Re: Beaverton-Hillsdale Highway TSM Project

SUBJECT: Beaverton-Hillsdale Hwy. Left Turn Lanes

SUBJECT: Beaverton-Hillsdale Highway Project Schedule

Re: Beaverton-Hillsdale Highway TSM project

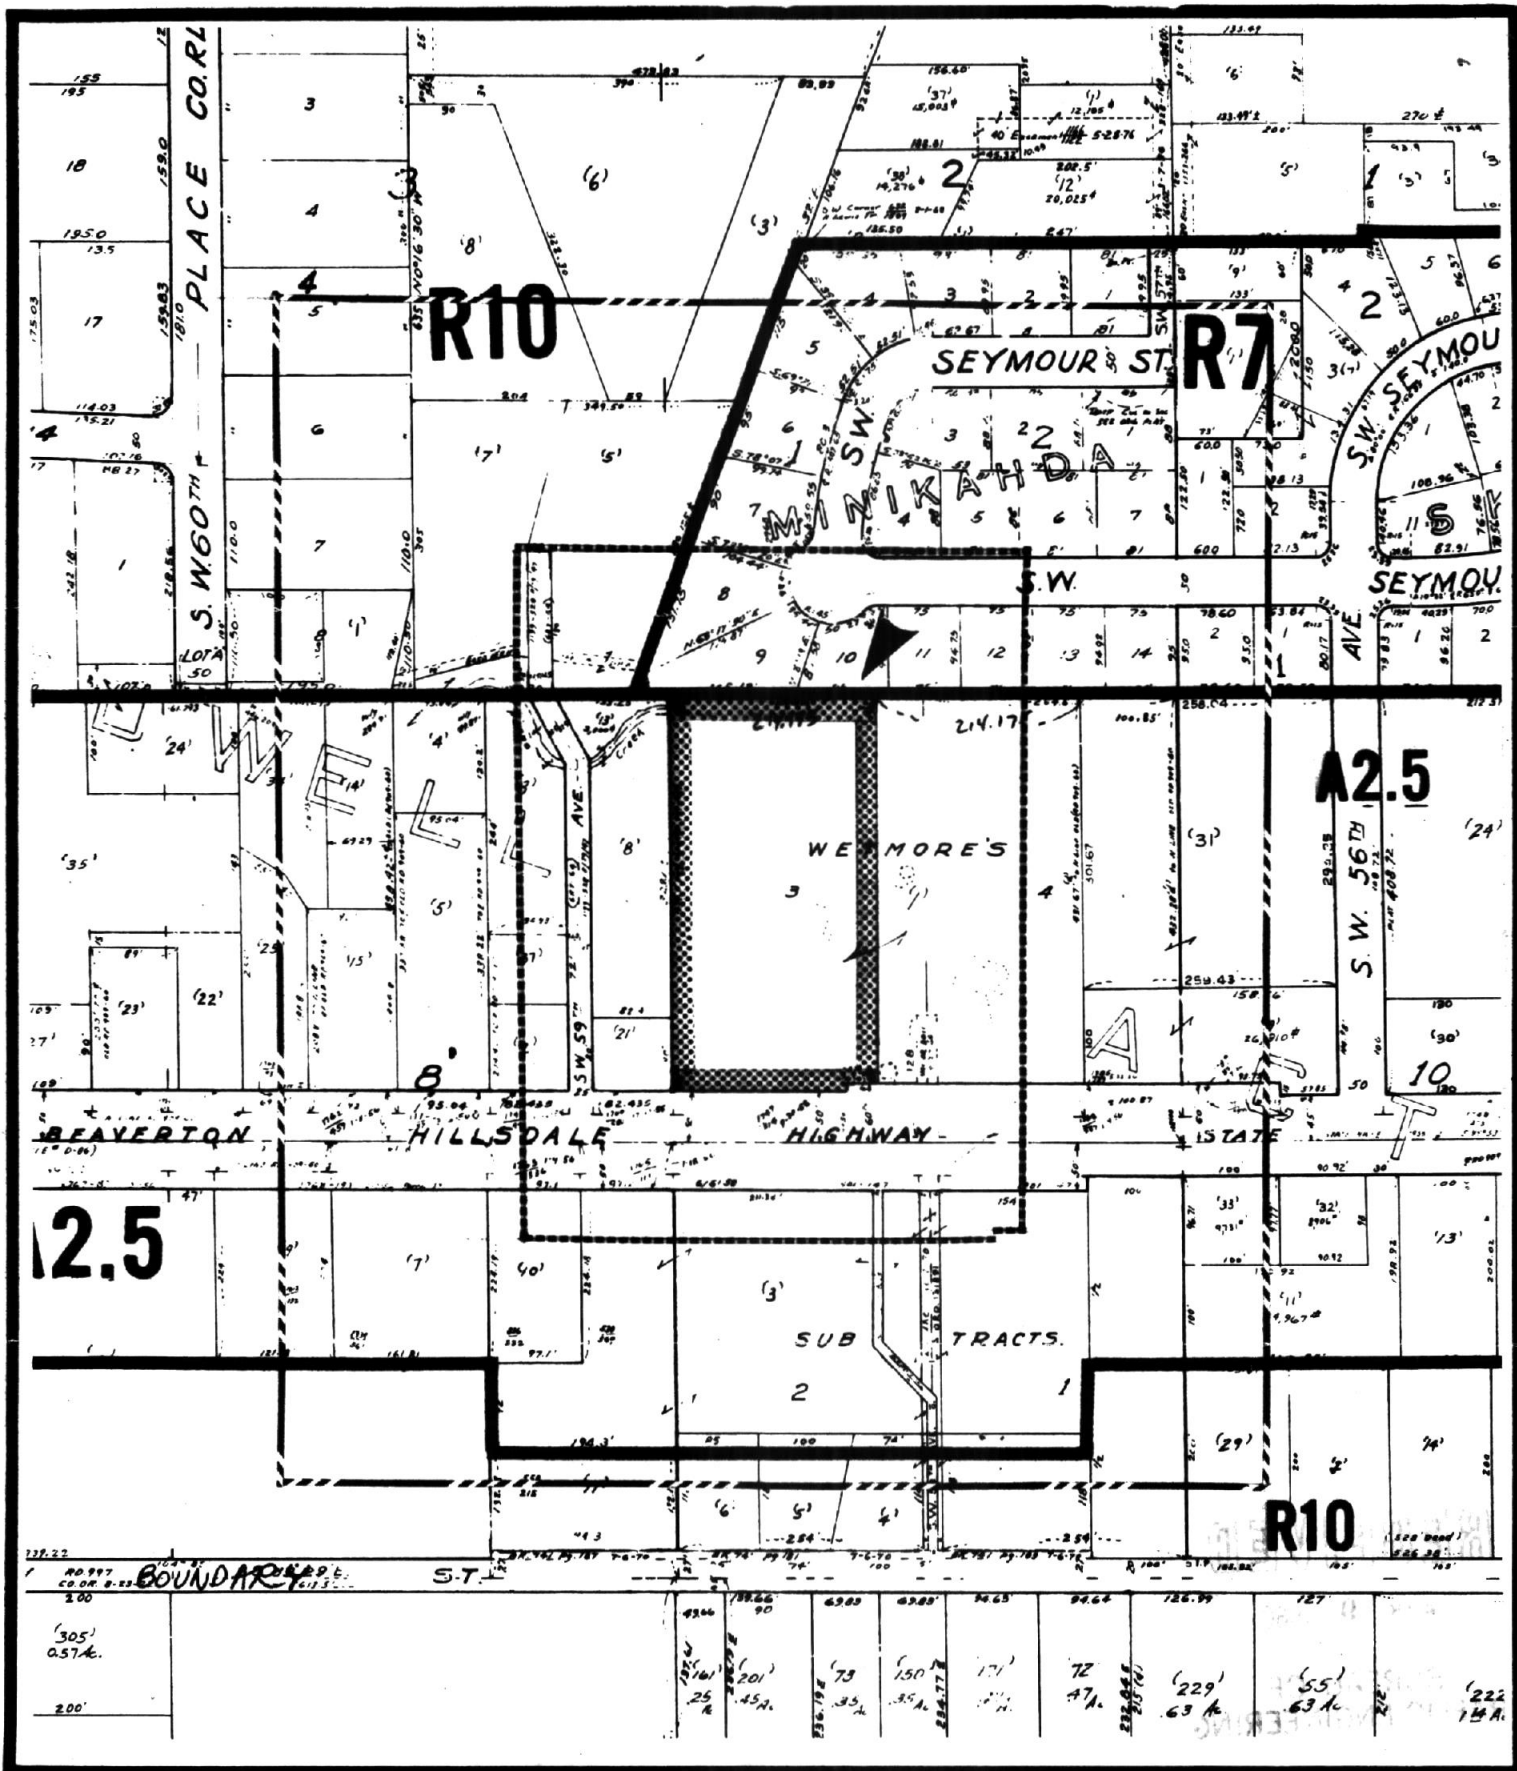
It is our opinion that a one space to eight units parking ratio is insufficient for this Elderly Housing Project for the following reasons:

1. Unlike other elderly units, this project does not have easily-accessible (walking), nearby shopping facilities. This would tend to draw more tenants with their own transportation.
2. Nearby on-street parking is non-existent. Parking on Beaverton-Hillsdale Hwy. is to be removed under an improvement project. Therefore, this project needs more of-street parking than allowed for others.

#2) In my opinion 1 car per 8 units is not enough - it should be a min. of 1 per 4 units because a) The setting is not typical of other elderly units in that stores/shopping areas are not as close for instance as the Union Manor in N.W. or the Sellwood Manor or the Holly wood units

non existent — B/Hillsdale will be
stripped of parking. This location needs
more off street parking than a usual
Elder Housing development.

We recommend a one space to four unit parking ratio with an area aside for additional parking should it become necessary.
